The Sizewell C Project

6.16 Ch Second Environmental Statement Addendum - Non-Technical Summary

July 2021

Figure 3 Summary of Proposed Change 18 Design Changes

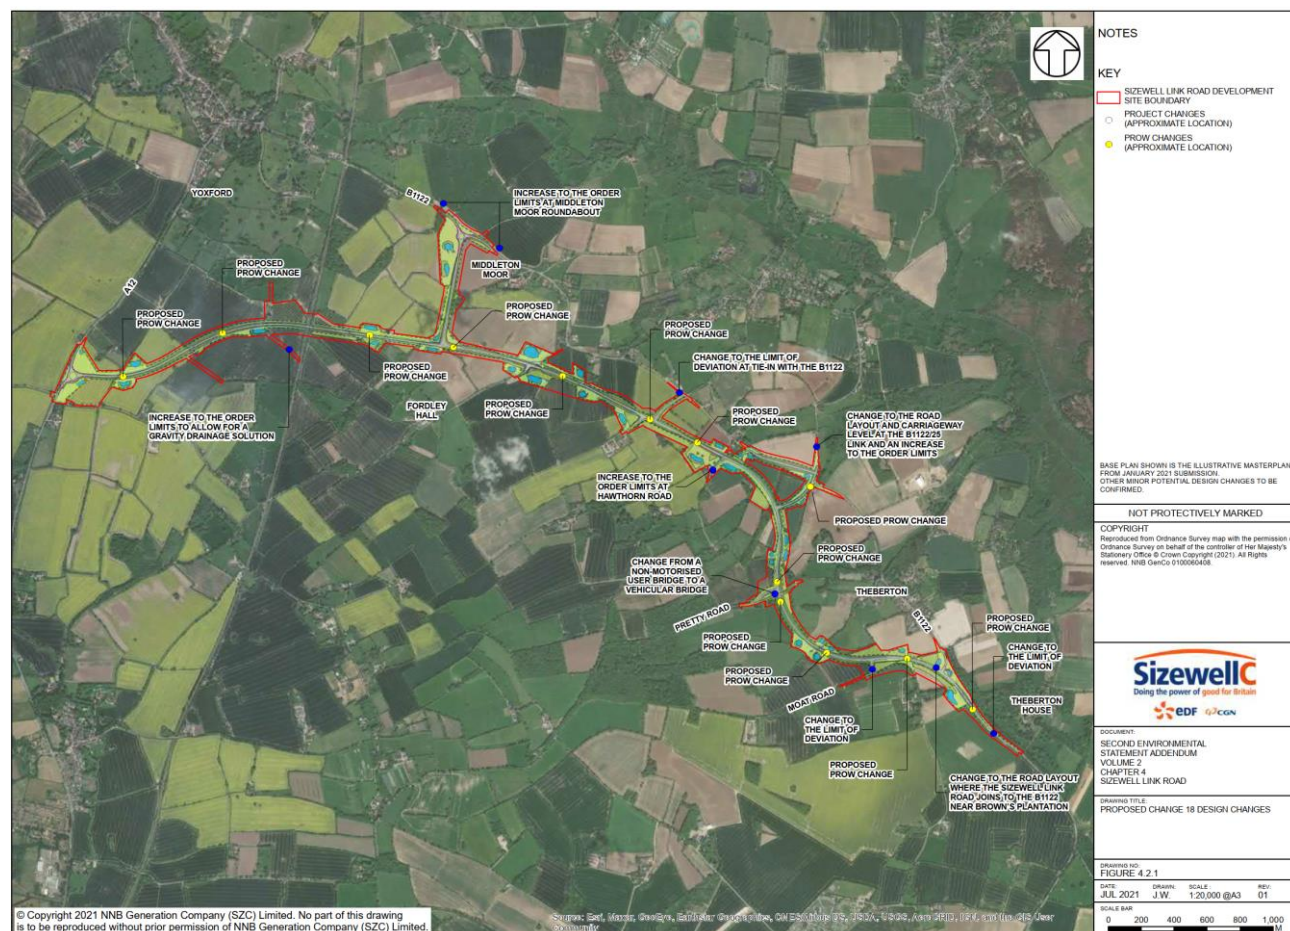
SZC Co. is proposing changes (Proposed Change 18) to the Sizewell link road site, as shown on **Figure 3**. These comprise:

- Change to Pretty Road bridge, comprising a change from a Non-Motorised User bridge (for use by pedestrians, cyclists, equestrians) to a vehicular bridge, to avoid the closure of Pretty Road to vehicular traffic and to increase connectivity across the route of the Sizewell link road. To facilitate this change, a junction between Pretty Road and the Sizewell link road on the south west side of the route is no longer included in the proposals.

- PRow amendments comprising changes to ensure that the PRow proposals provide safe crossing points and reflect topography.
- Additional land for drainage to allow for a gravity drainage solution to be achieved to the west of the East Suffolk line.

- A change to the road layout (including a change to the boundary of Work No. 12B shown on **Works Plans** (Doc Ref. 2.3(D) Ch)) where the Sizewell link road joins the B1122 near Brown's Plantation to address a departure from road design standards.

- A change to the road layout and carriageway level at the B1122/25 link to address a departure from road design standards resulting in an increase to the site boundary. This change would also require an amendment to the boundary of Work No. 12B shown on **Works Plans** (Doc Ref. 2.3(D) Ch).

- A small increase to the site boundary is proposed at Hawthorn Road. This would allow for an improved tie in between the proposed Sizewell link road and the existing Hawthorn Road. This change would also require an amendment to boundary of Work No. 12B shown on **Works Plans** (Doc Ref. 2.3(D) Ch).

- Small increases to the site boundary and a change to the boundary of Work No. 12B shown on the **Works Plans** (Doc Ref. 2.3(D) Ch) are proposed at the Middleton Moor

roundabout. This is to allow for an improved tie in between the eastern and western arms of the proposed Middleton Moor roundabout and the existing B1122.

- Minor revisions to the boundary of Work No. 12B shown on **Works Plans** (Doc Ref. 2.3(D) Ch) are proposed at the

Trust Farm Link/B1122 junction, the Moat Road junction and at the eastern end of the Sizewell link road where it joins the existing B1122. This is proposed to accommodate the detailed design of the road and allow for improved tie ins with the existing highway.
